Water License Pre-Hearing Technical Meeting Information Supplement

**Doris North Project
Nunavut, Canada**

June 2007

The following supplemental information is provided in response to the Table of Issues generated during the Doris North Pre-Hearing Technical Meeting held in Cambridge Bay on June 11th and 12th, 2007.

Figure 1: Roberts Bay Fuel Tank Facility

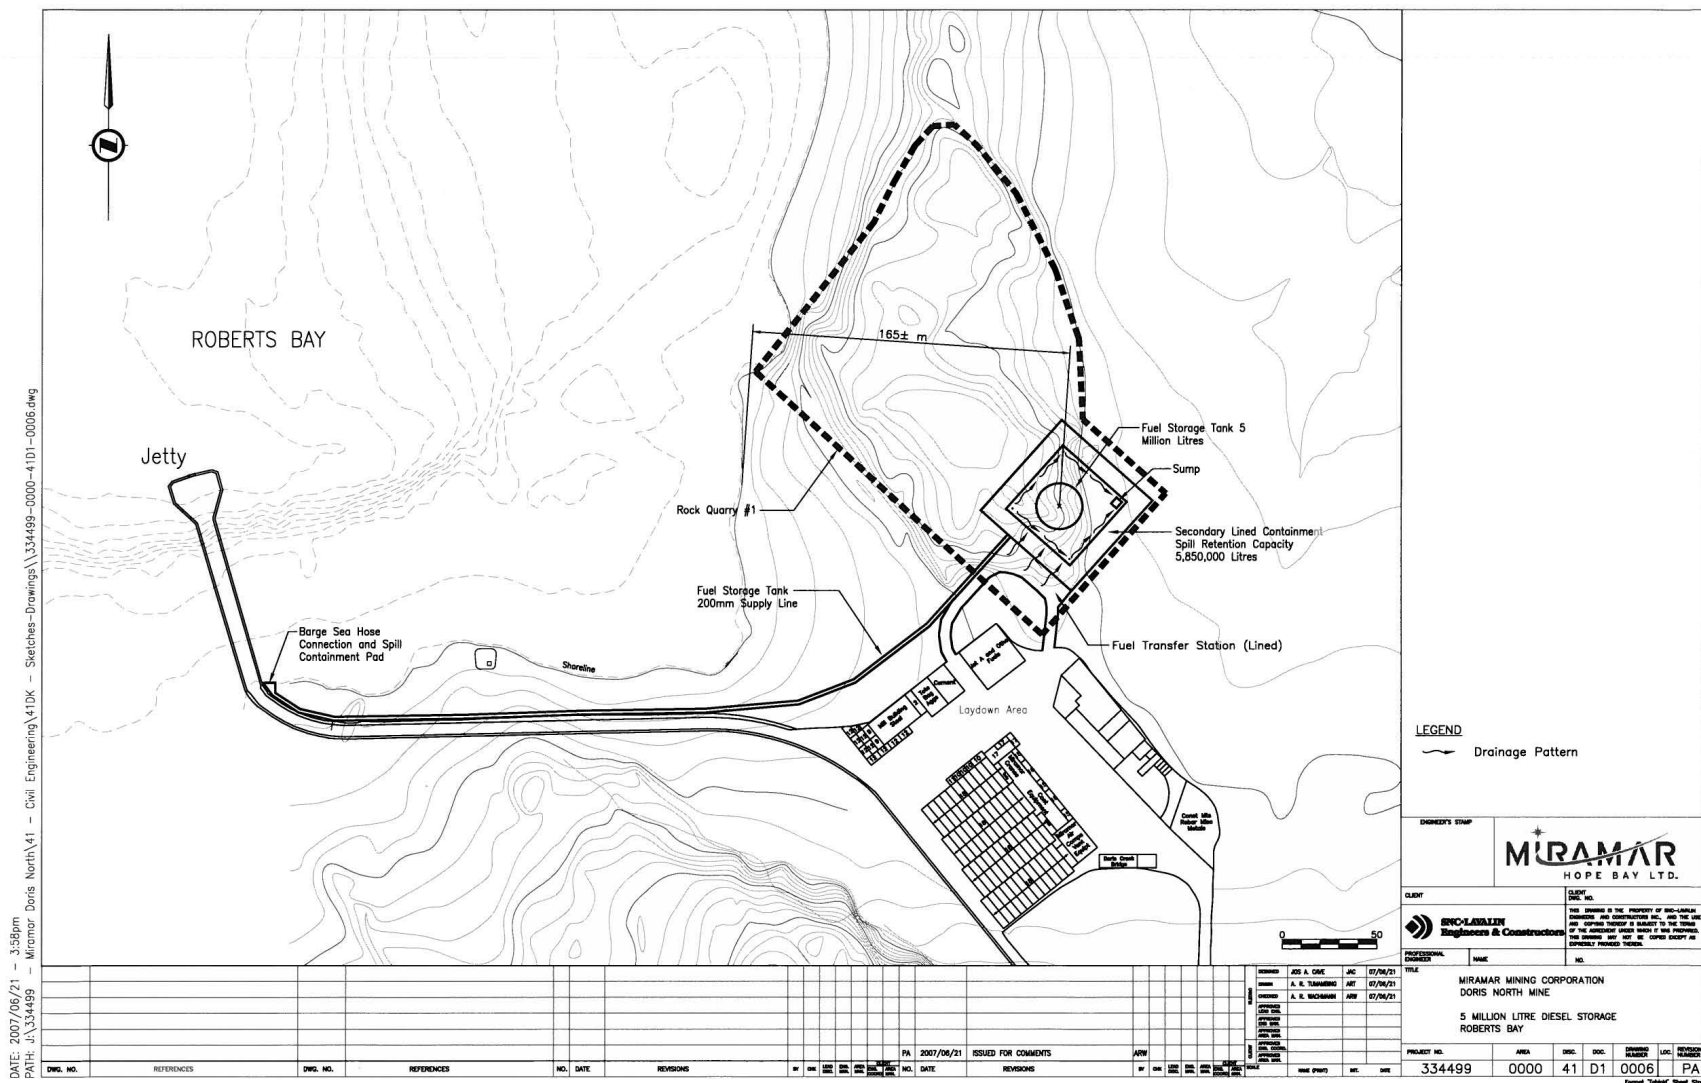
SNC-Lavalin recommended to MHBL that the amount of on-site fuel storage capacity should be increased from a 12 month to a 14 month supply, to ensure continuity in operation and allow for contingency in the event of a colder winter or other change that results in higher fuel consumption. Consequently MHBL has requested authorization from the Nunavut Water Board to add an additional fuel tank and containment system to the May 2007 Water License Application. This storage tank and the lined secondary containment berm will be constructed on a bedrock foundation sited within the footprint of Quarry 1 at Roberts Bay. This facility is designed to accommodate a single storage tank with a 5.0 million litre capacity (reduced from the 5.7 million litre capacity quoted in

MHBL's letter of June 08th) and will be sited approximately 150 m back from Roberts Bay at its closest point. The proposed Roberts Bay fuel transfer station covered by the NIRB Project certificate will be relocated to be sited adjacent to this new fuel storage tank so that all fuel trucks would be loaded inside a bermed containment liner. The SNC-Lavalin drawing showing the layout and location of this proposed fuel tank storage facility and the proposed piping connection to the jetty are attached to this supplement as Figure 1.

The lined and bermed secondary containment facility will have a capacity of 5.85 million litres (>110% of the tank useable capacity) and have a footprint of approximately 50 meters square (area of ~2,500 m²).

This 5 million liter capacity fuel tank facility will be constructed on a level precision blasted surface, on the exposed bedrock within the footprint of Quarry #1. Founding the tank farm on bedrock eliminates the risk of foundation settlement, which may lead to pipe rupture and fuel spills.

Figure 2: Doris Lake Freshwater Barge

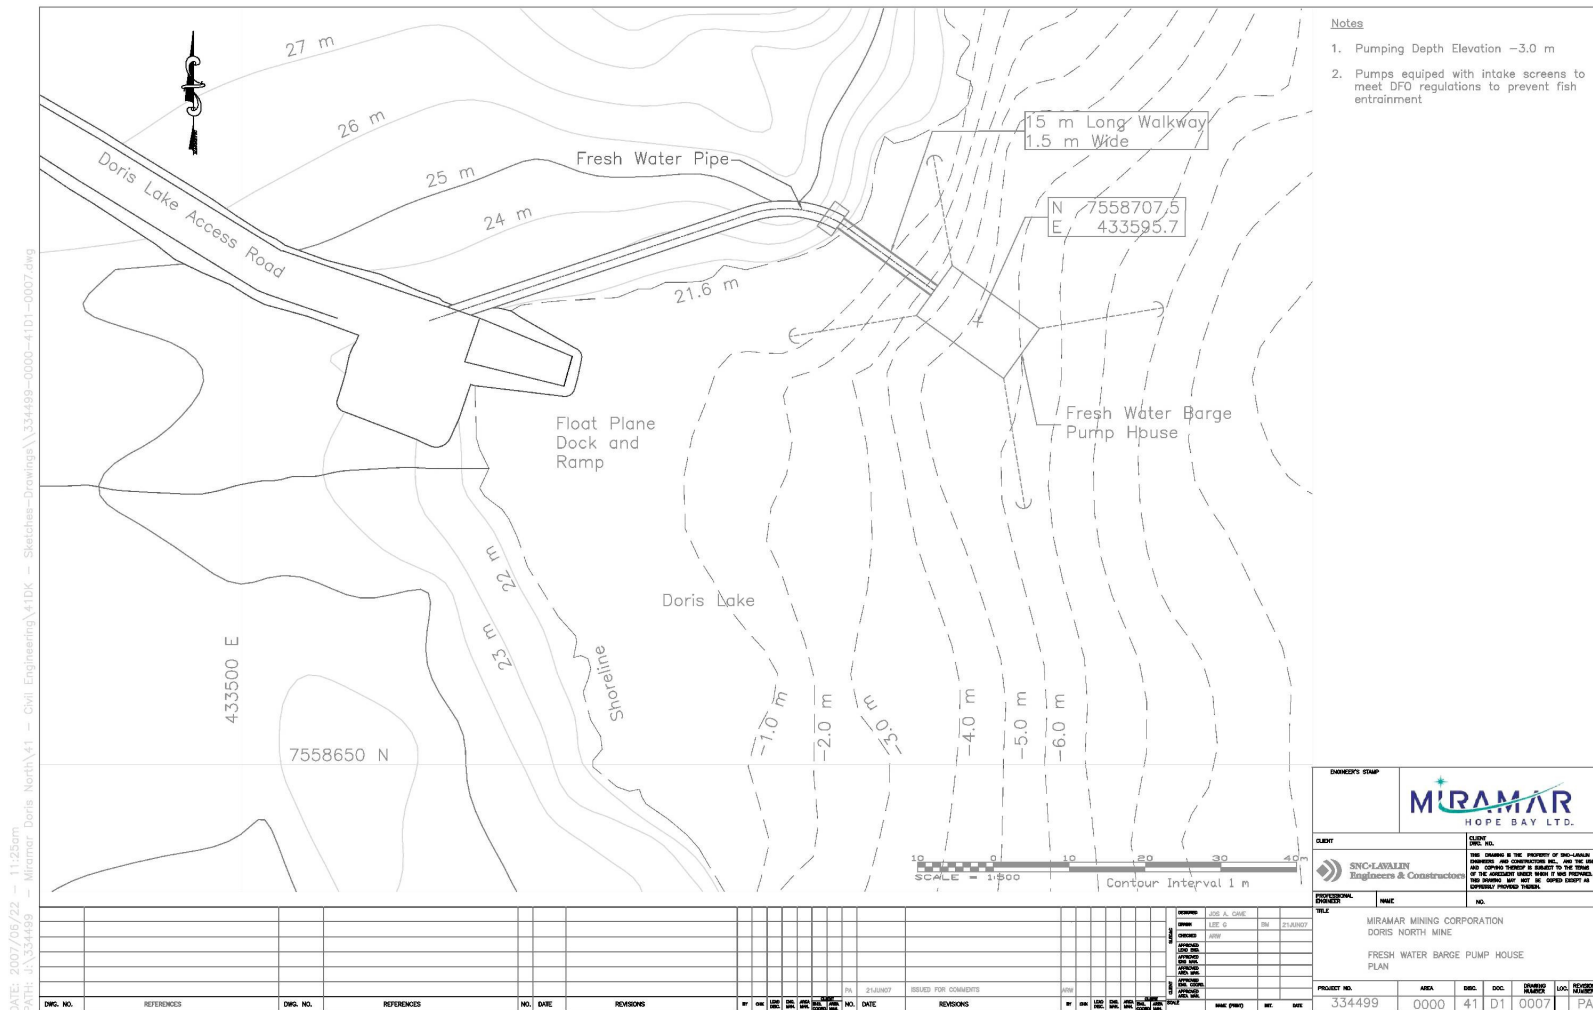
Based on a recommendation from SNC-Lavalin, MHL has decided that the 4" HDPE DR 17 fresh water pipe intake to be sited on the bottom of Doris Lake feeding an on-shore wet well, proposed in the April Water License Application re-submission, be replaced with a floating barge system with an approximate in-lake footprint of 10 square metres. The floating pump house barge will be equipped with an aerator bubble system to keep the barge from freezing solidly in place. SNC-Lavalin feels that the floating barge system is more suitable for the small volume of water to be drawn from Doris Lake and easier to install and maintain. SNC-Lavalin cites successful use of similar pumping systems at other sites in the North. In this way the entire system can be fabricated off-site and shipped as a module for direct placement. This modification will remove any lake bottom impacts potentially associated with the HDPE pipe laid along the lake bottom and anchored in place with clean rockfill. There would be no change in the volume of water drawn from Doris Lake and the bubbling system will only affect the ice within 6 inches of the floating barge and thus does not create any new hazards to wildlife or humans traveling on the frozen lake in winter. This modification will remove any potential impact on fish habitat caused by a pipe on the lake bottom. Overall in MHL's opinion the potential environmental effect from this change is positive as it eliminates any impact on the lake bottom. This style of pump intake is in line with that previously requested by DFO during the NIRB process.

The proposed floating pump house location is shown in Figure 2. The pump house barge will be anchored in Doris Lake at a point approximately 25 metres to the east of the Doris Lake float plane dock. The pump will be set to pump from a depth of approximately 3 metres. The lake at the proposed pump barge location is approximately 5 metres deep. The pump intake will be equipped with a screen that meets DFO guidance to prevent fish entrainment. The pump house will be connected to the shore by a 15 m long by 1.5 m wide pre-fabricated clear span walkway that ties the pump house to the shore. The fresh water pipeline will be cantilevered along the side of this walkway and then travel along the road right-of-way back to the fresh water storage tanks at the accommodation camp.

Figure 3: Construction Road Turnouts

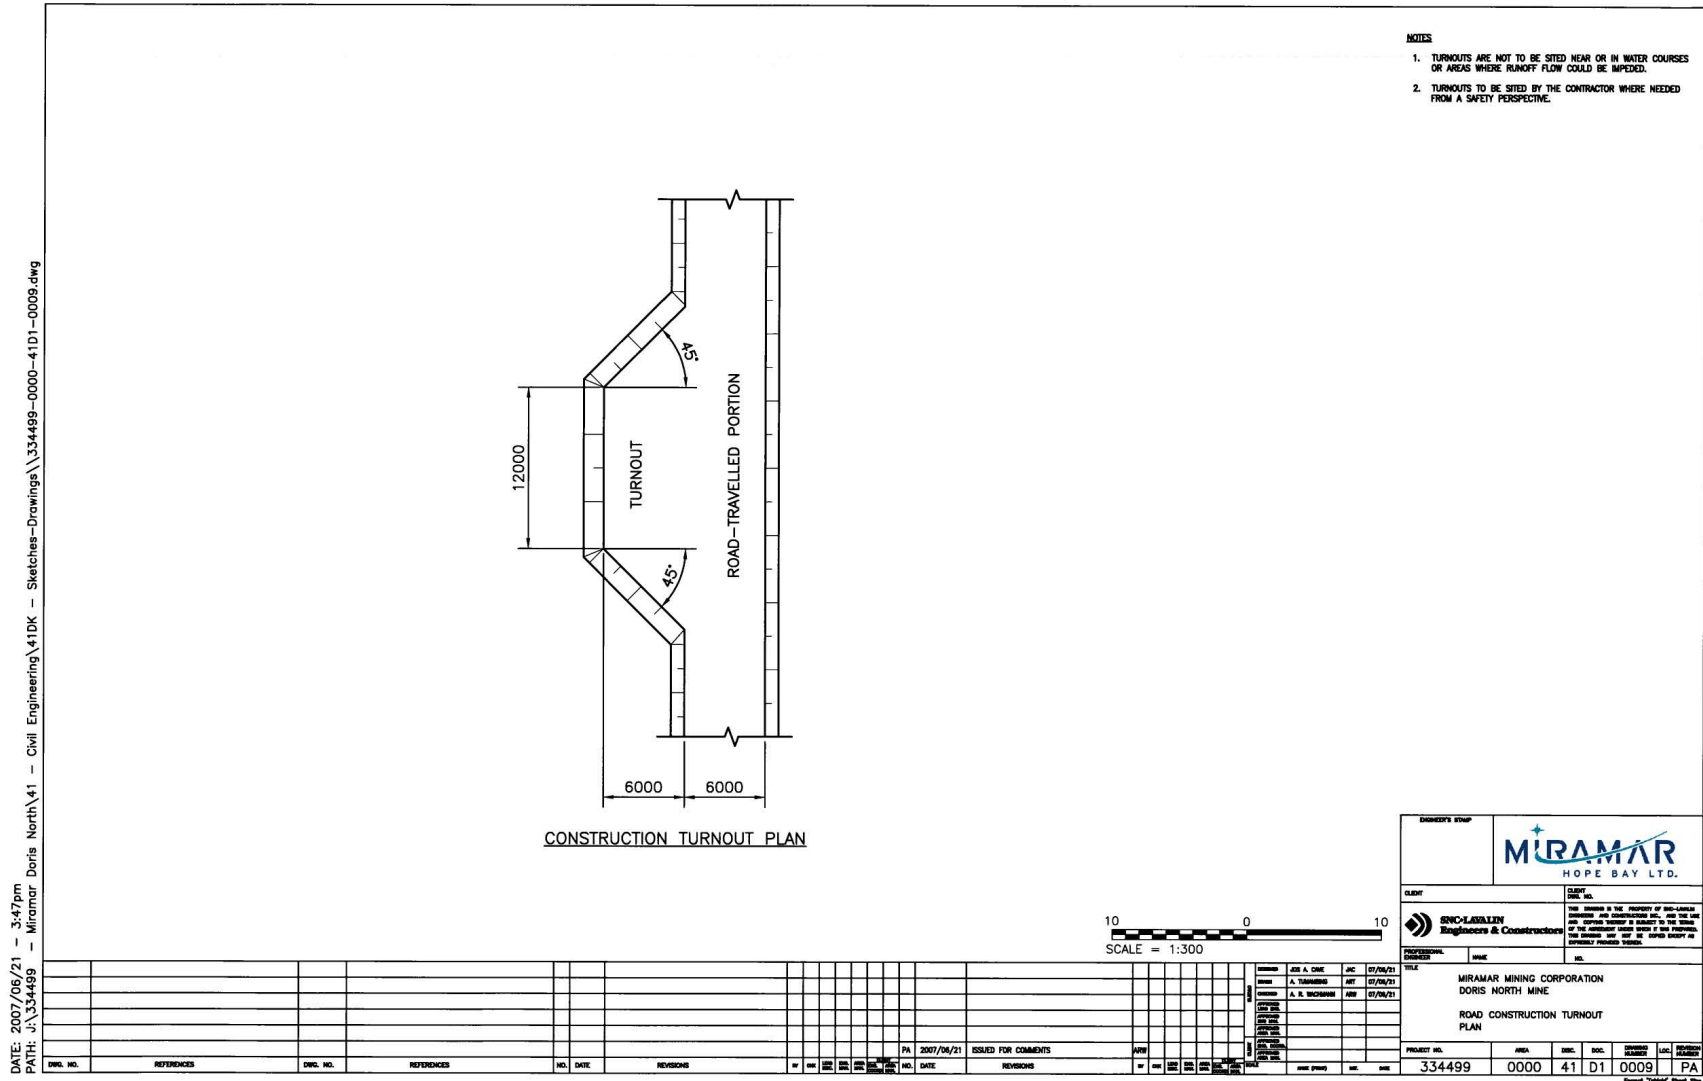
The current access road design calls for a single lane road between Roberts Bay and the plant site with passing turnouts sited at 1 km intervals. This remains unchanged, however SNC-Lavalin has pointed that in constructing a single lane road, a number of construction turnouts will be required to allow the construction dump trucks to safely turn around to dump their loads. The contractor will install these turnouts where they are needed for safe turning of the trucks. None of these turnouts will be constructed in or adjacent to water courses or areas where drainage flows could be impeded by these turnouts. This is a safety requirement and a change in the road design has been submitted to the NWB. It is estimated that approximately 35 of these turnouts will be needed to allow for safe construction of the Roberts Bay access road (turnouts will not be needed for the widened airstrip portion of the road). Each turnaround will be approximately 6m x 12m (72 sq m). The total additional surface footprint from these turnouts will be approximately 0.25 hectares which is still significantly less than if the width of the road had been increased to a double lane road. In MHBL's opinion these additional road turnouts will not have a significant environmental impact and thus this change is seen as being neutral. Attached as Figure 3 is an engineered drawing from SNC-Lavalin showing a typical road construction turnout.

Figure 4: Typical Rock Drain For Roads

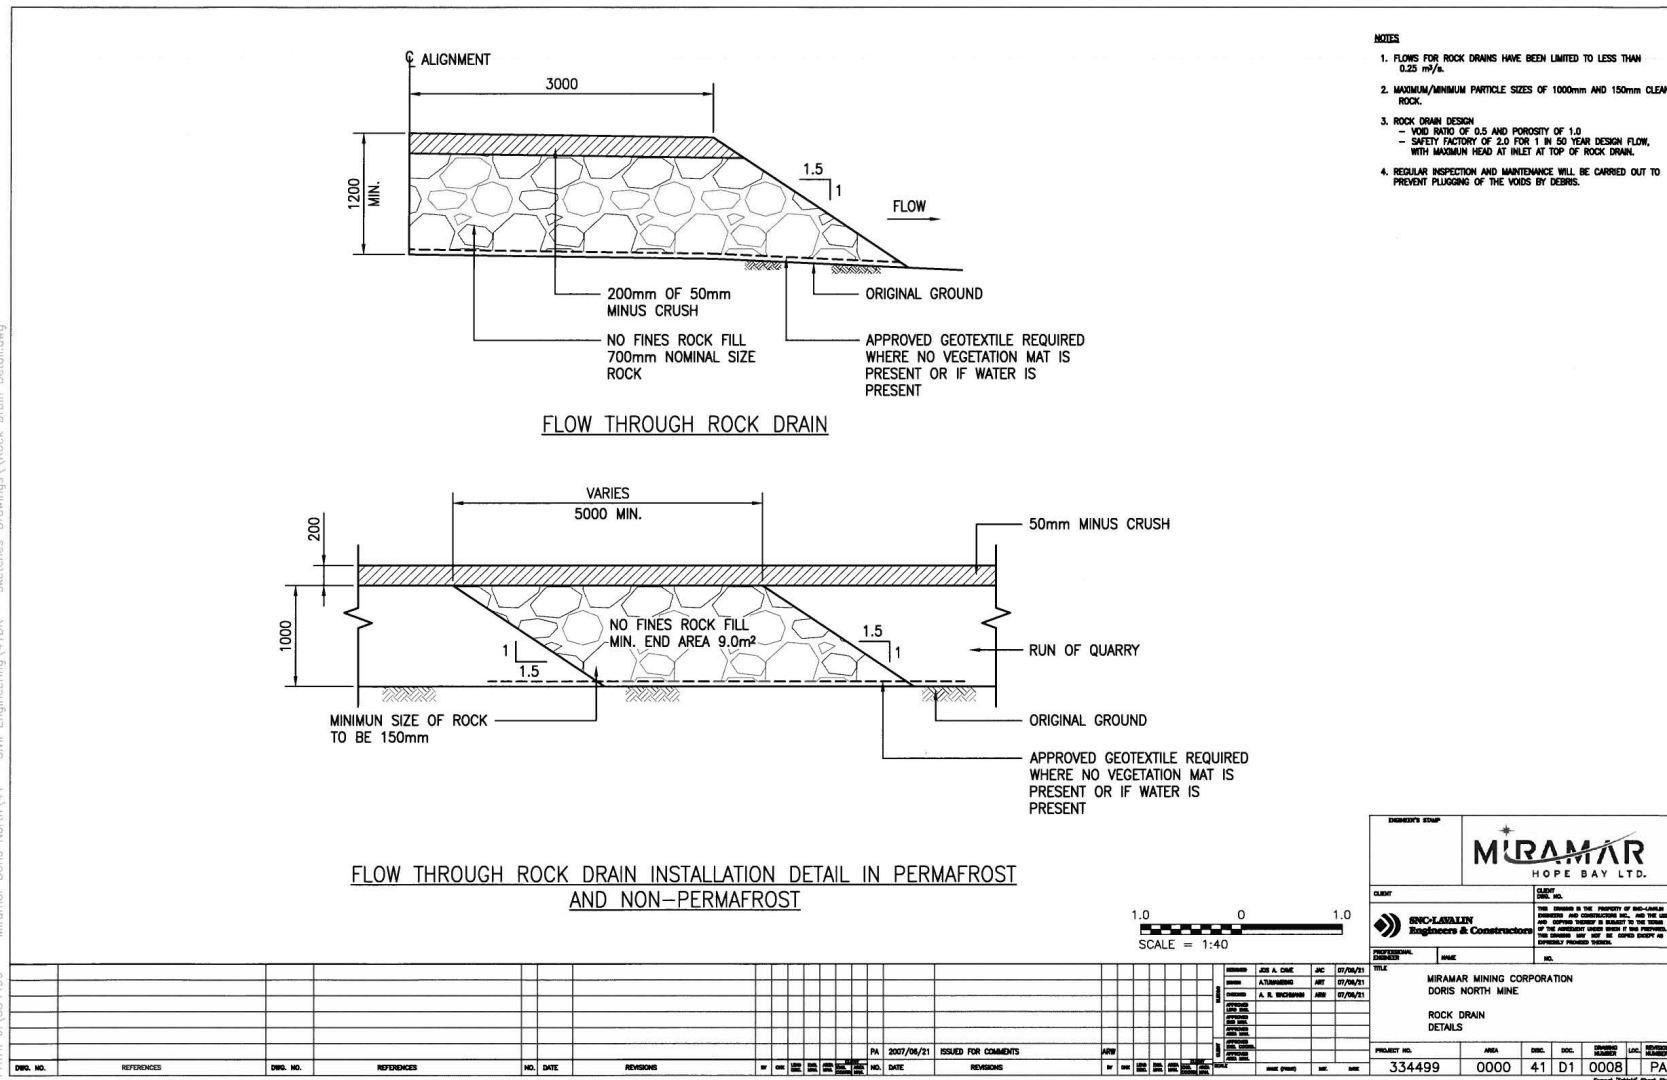
Based on a recommendation from SNC-Lavalin, MHBL proposes that all culverts, planned where the site roads cross low flow (less than $0.25 \text{ m}^3/\text{s}$) ephemeral drainages that have no fish access potential, be replaced by rock drains. This recommendation is based on SNC-Lavalin's experience at other Northern sites where typically the culverts remain frozen after the freshet flow commences in the spring turning the culverts into flow obstructions until they can be thawed using applied heat. SNC-Lavalin proposes that these rock drains consist of coarse rock that has been screened to remove fines. In their experience, these rock drains perform better in the North at passing the spring freshet flows. These will only be used where the drainage pathways have no defined stream and thus no potential for fish access and where flow is expected to be less than $0.25 \text{ m}^3/\text{s}$. SNC-Lavalin has prepared a typical rock drain design and specification which is attached as Figure 4. This design is based on an approved GNWT Highway design used on SNC-Lavalin's design build contract for NWT Highway 3 near Yellowknife. SRK have reviewed this design and provide the following conclusion:

“The presence of the rock drains is not expected to affect the thermal performance of the road and/or pads in any way. If the rock drains do not function as planned and result in pooling MHBL will remove the problem rock drains and replace with a working culvert.”
